BUILDING STANDARDS COMMISSION

RE: Ordinance #1484, 1486, 1487, 1488, 1490

AN ORDINANCE INCORPORATING THE 2013 CALIFORNIA BUILDING CODE ("CBC") BY REFERENCE AND AMENDING THE CBC BASED UPON LOCAL CLIMATIC, TOPOGRAPHIC, AND GEOLOGICAL CONDITIONS.

1807.1.6 Prescriptive design of concrete and masonry foundation walls.

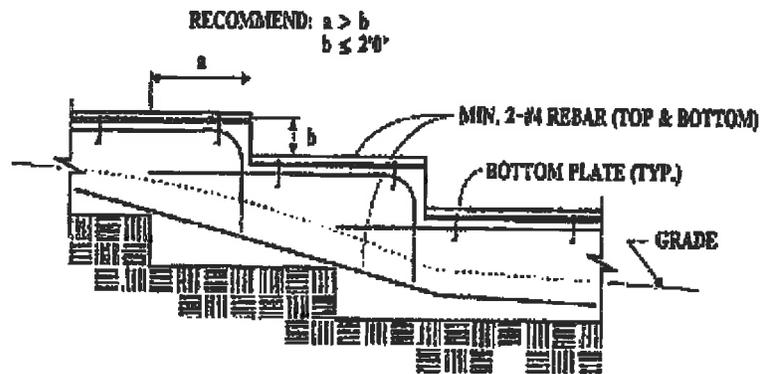
Section 1807.1.6 of Division II of Chapter 1 of the CBC is amended to read as follows:

Concrete and masonry foundation walls that are laterally supported at the top and bottom must be permitted to be designed and constructed in accordance with this section. Prescriptive design of foundation walls cannot be used for structures assigned to Seismic Design Category D, E or F.

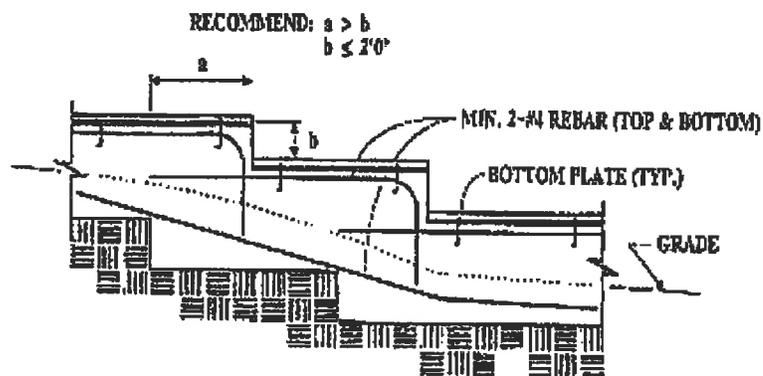
In Seismic Design Categories D₀, D₁ and D₂ where construction joint is created between a concrete footing and a stem wall, a minimum of one No. 4 bar are installed at not more than 4 feet (1219 mm) on center. The vertical bar

cannot extend to 3 inches (76 mm) clear of the bottom of the footing, have a standard hook and extend a minimum of 14 inches (357 mm) into the stem wall.

**FIGURE R602.10.6.1
METHOD ABW—ALTERNATE BRACED WALL PANEL**

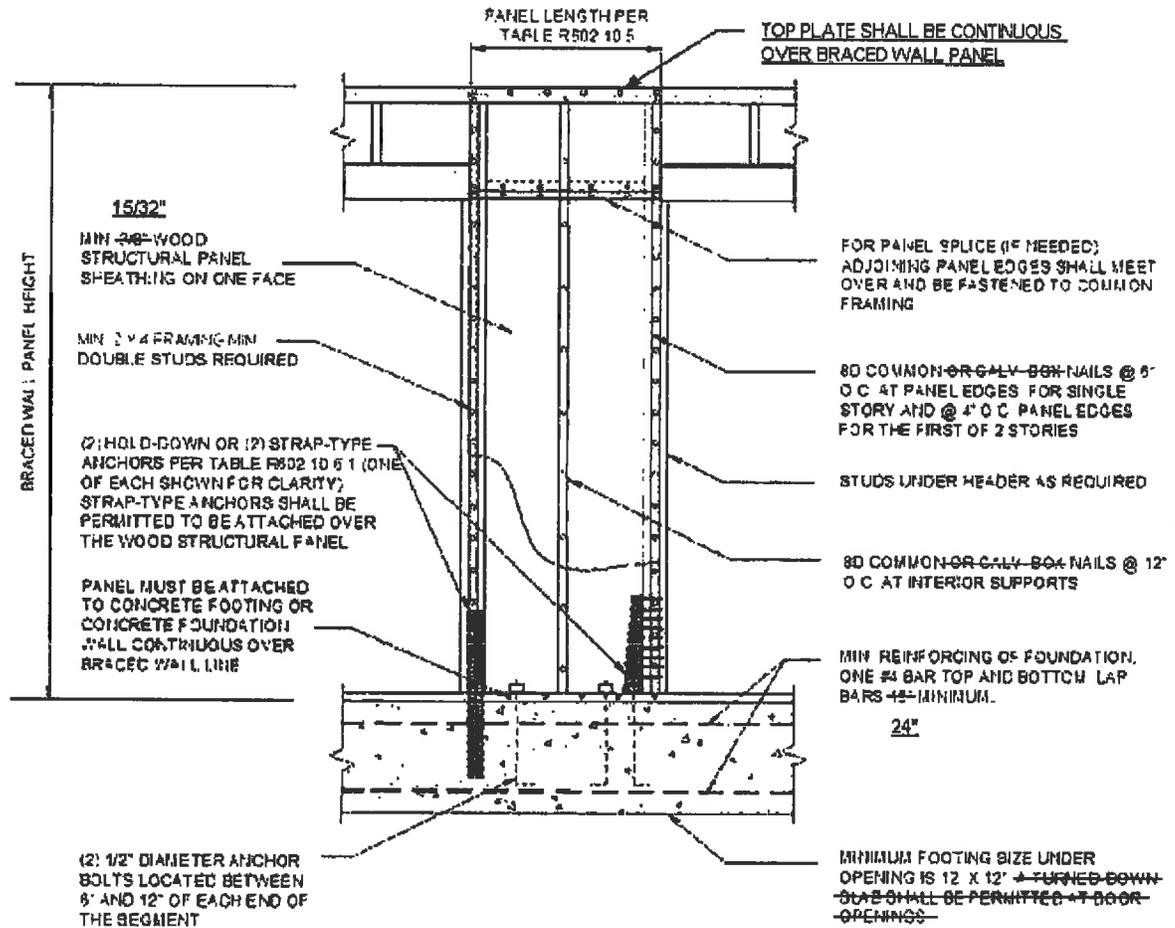
Figure R602.10.6.1 of the 2013 Edition of the California Residential Code is amended to read as follows:

FIGURE R602.10.6.2
METHOD PFH—PORTAL FRAME WITH HOLD-DOWNS
AT DETACHED GARAGE DOOR OPENINGS

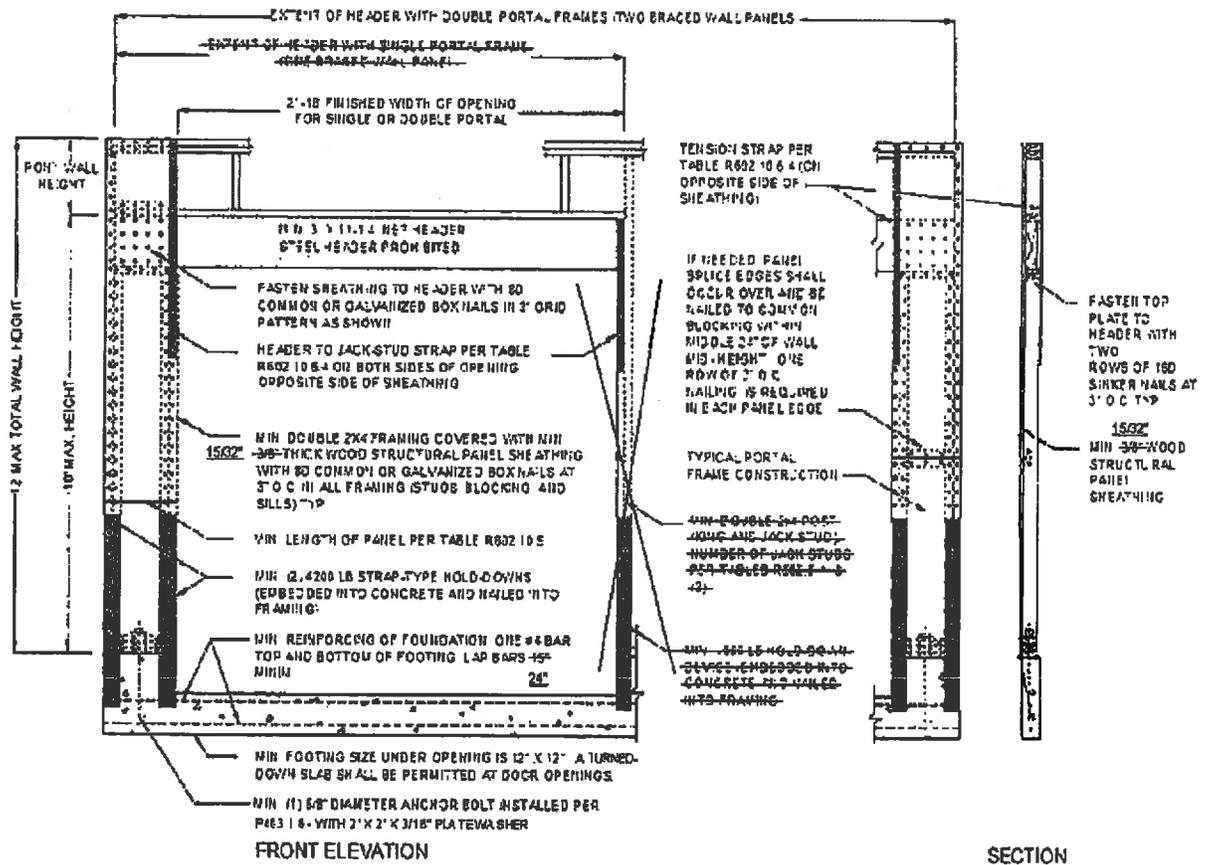
Figure R602.10.6.2 of the 2013 Edition of the California Residential Code is amended to read as follows:

FIGURE R602.10.6.1
METHOD ABW—ALTERNATE BRACED WALL PANEL

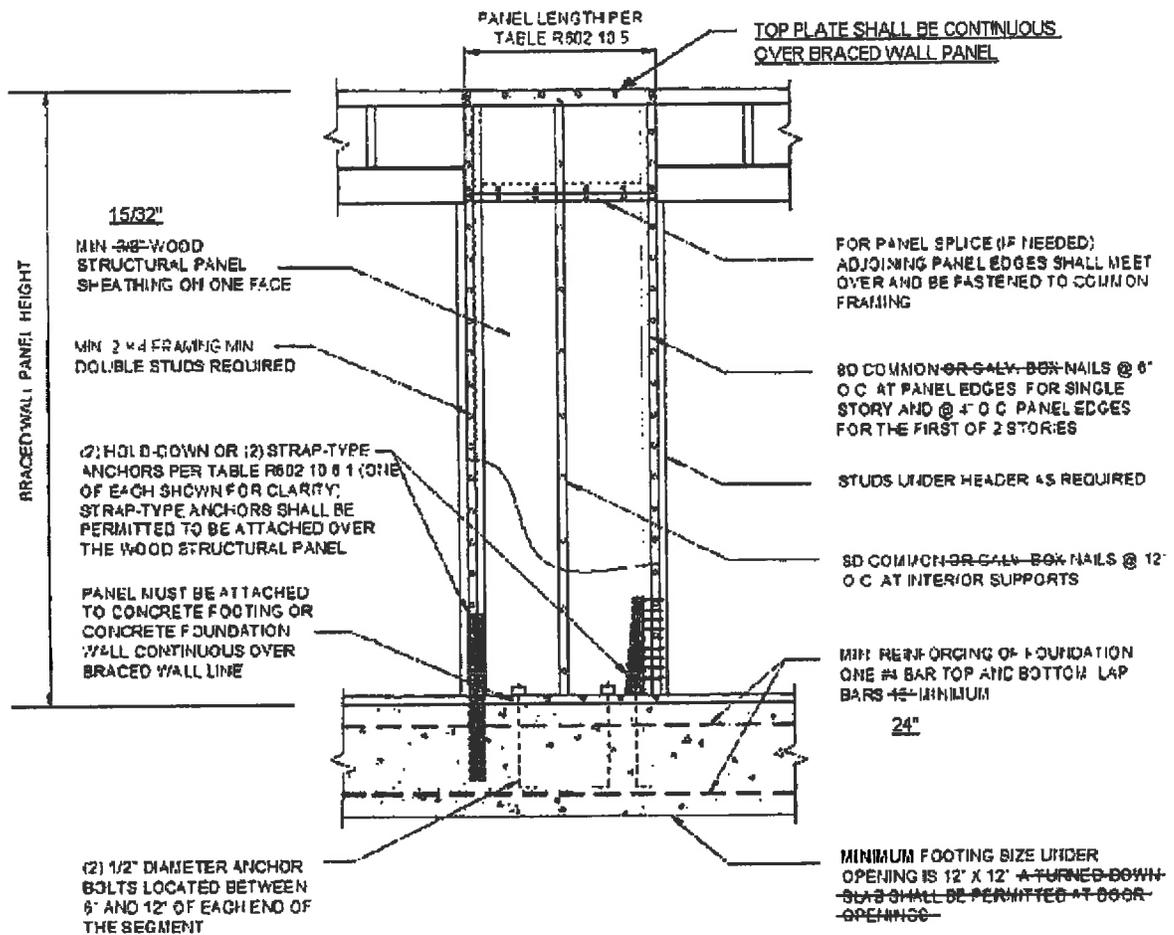
Figure R602.10.6.1 of the 2013 Edition of the California Residential Code is amended to read as follows:

FIGURE R602.10.6.2
METHOD PFH—PORTAL FRAME WITH HOLD-DOWNS
AT DETACHED GARAGE DOOR OPENINGS

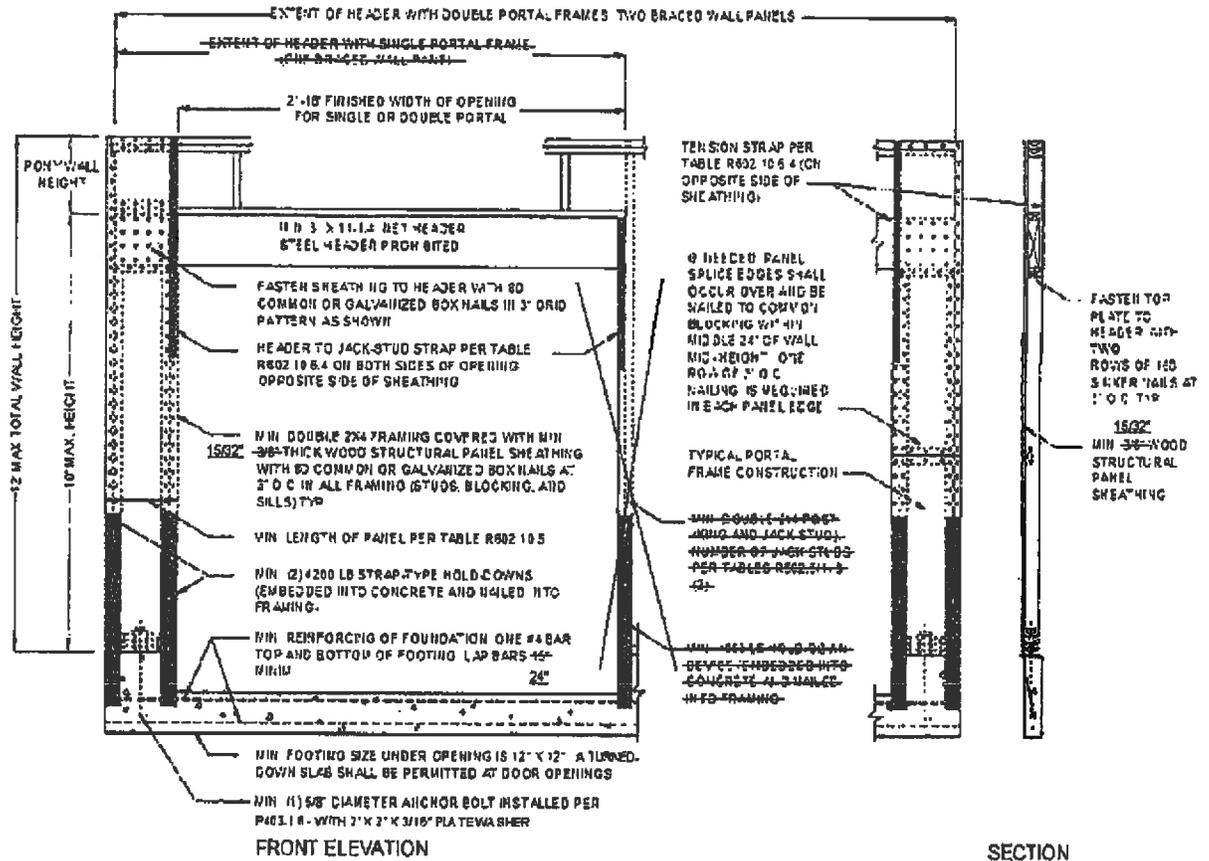
Figure R602.10.6.2 of the 2013 Edition of the California Residential Code is amended to read as follows:
